Subject: Interim Report - DER 83-11
A 50.55(e) Potentially Reportable Deficiency Relating to Exide
Batteries May Leak or Corrode at Terminals Due to Cracking of
Plastic Seals/Covers
File: 83-019-026; D.4.33.2

INTERIM REPORT - DER 83-11
POTENTIAL REPORTABLE DEFICIENCY
ARIZONA PUBLIC SERVICE COMPANY (APS)
PVNGS UNIT

NOTICE TO OPERATORS OF EXIDE GN CLASS 1E BATTERIES

FIG. 1

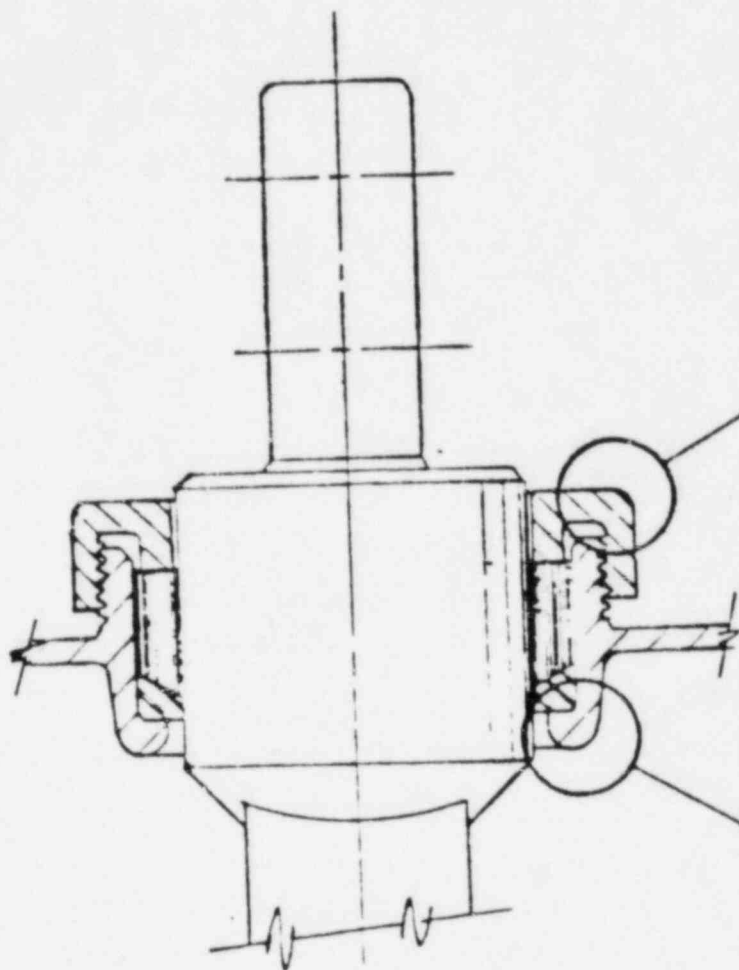
The design of the seal (see Fig. 1) involves the compression of a rubber sleeve, or gland, against the lead terminal post. The gland is held in compression by the cover and the seal nut.

Unfortunately, the stress on these plastic components, over a period of years, can cause them to crack. The plastic boss at the base of the seal can crack as shown in Fig. 2, or the seal nut can crack as shown in Fig. 3.

The effect of either type of cracking is the same in that it relieves the pressure on the gland, thereby allowing the seal to "leak", that is, to allow acid to migrate slowly up the posts. Given that the intercell connectors are tight, as they should be, this leakage should cause no problems.

A procedure has been developed for permanent repair, which is now being refined, and submitted for qualification, for reducing the rate of the leakage. This can be carried out on site by EXIDE personnel, and should be implemented during your next planned shutdown.

It is based on the principle of eliminating all stresses on the plastic parts, and creating a new seal, of stress-free design, above the old seal location.

1. Disconnect and remove all intercell, intertier and terminal connectors.
2. Remove all red and black terminal seal plastic nuts.
3. Remove rubber glands from inside the seals.
4. Rebuild the seals using "O" rings with liquid sealing compound and new red and black caps.
5. Clean connectors and terminal posts and reassemble hardware in accordance with instructions including micro-ohmometer readings.
6. Return the battery to service.

FIG. 4

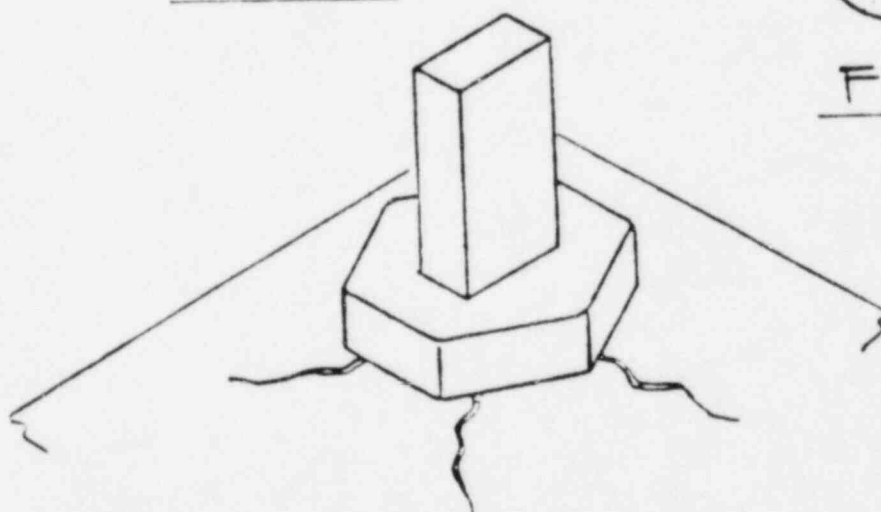
The consequence of nodular corrosion is to create additional stress on the plastic components, this time in a radial direction. This stress can lead to radial cracks in the cell cover (Fig. 4). A small number of cells have been reported with this condition.

This procedure will not only correct the primary fault, by reducing stress, but will also correct the secondary fault if it exists. Any nodular corrosion present will be "quenched" if allowed exposure to the acid in the cell.

A final corrective action, necessary only for the few units which have radial cracks in the covers, is a "flood-pour" cover repair. This relatively simple technique creates an all-enveloping secondary cover above the old one, sealing off any cracks. The flood pour technique should be used only if many cracks are present. For small, isolated cracks, individual repair is preferable.
